CALIFORNIA COASTAL COMMISSION

**RECORD PACKET COPY****STAFF REPORT: REGULAR CALENDAR****APPLICATION NUMBER:** 5-03-013**APPLICANT:** MT No. I LLC, Jim Johnson CEO and President**AGENTS:** Nancy Lucast, Lucast Consulting
Mark R. McGuire, Esq.**PROJECT LOCATION:** Northwest of the intersection of Avenida Pico and N. El Camino Real, City of San Clemente (Orange County)

PROJECT DESCRIPTION: Residential and commercial development, public park, trails and open space and associated infrastructure including roads and utilities on the 201.38 acre portion of the Marblehead property within the coastal zone. Included are a property subdivision and construction of 313 single family homes on 44.24 acres, 141,506 square feet of commercial space in ten commercial buildings on 22.3 acres, 15.43 acres of public parks; 95.04 acres of public and private open space and pedestrian and bicycle trails; 12.43 acres of private streets; 10.91 acres of public streets; more specifically described in Section II.A. of this staff report. The application also requests follow-up approval for emergency bluff stabilization grading that occurred in the early 1990s.

SUMMARY OF STAFF RECOMMENDATION:

EXHIBIT 19C

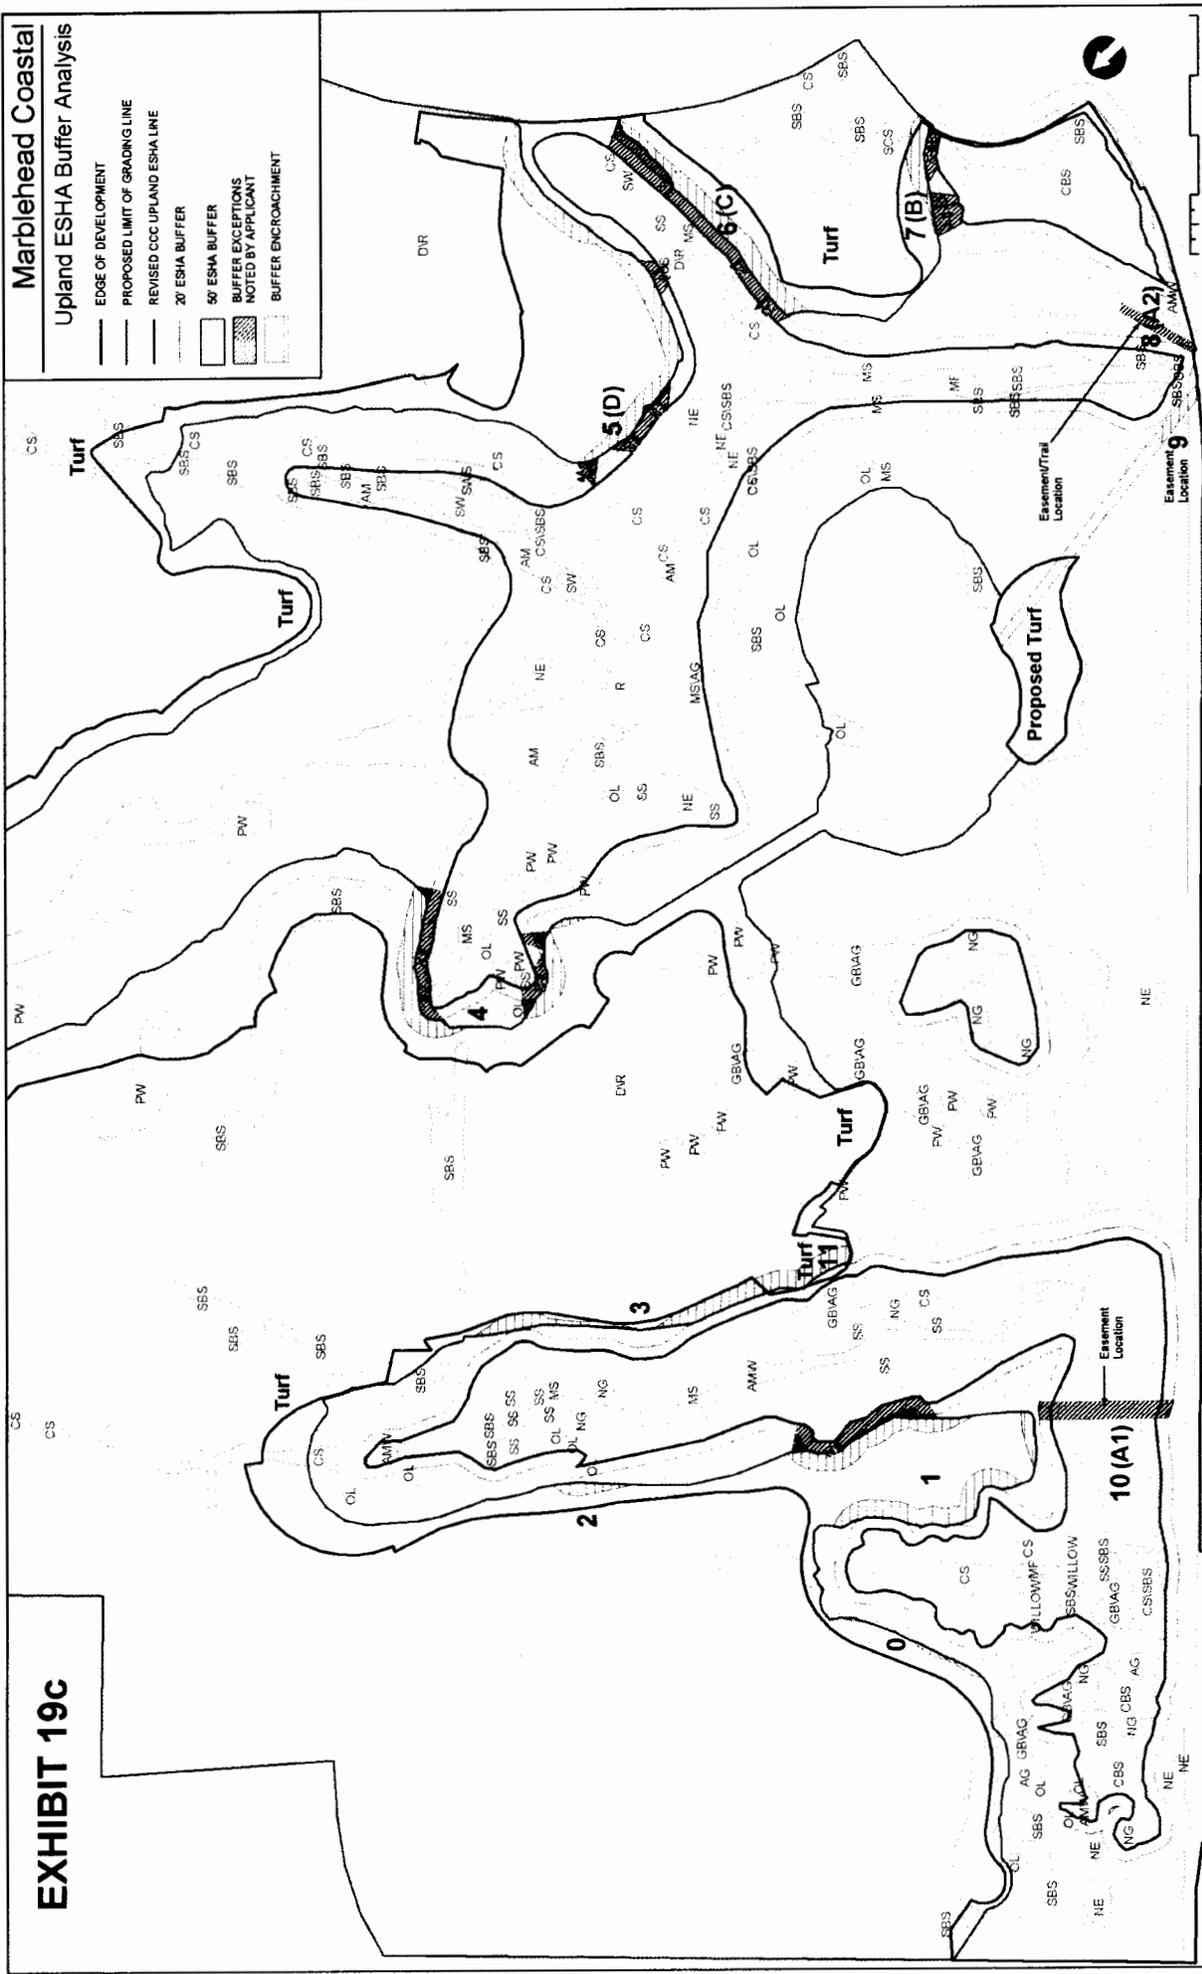
The proposed plan includes encroachment of grading or permanent development into the recommended ESHA or ESHA buffer at several locations. The applicant requests exceptions to the ESHA and ESHA buffer policies in these areas. The locations of the proposed buffer encroachments are shown in Figure 3. They include narrow buffers within encroachment areas shown in Exhibit 1 to Jim Johnson's March 7, 2003 letter to Karl Schwing (red hatched areas) and additional encroachment areas identified by staff (green hatched). They are discussed by number below.
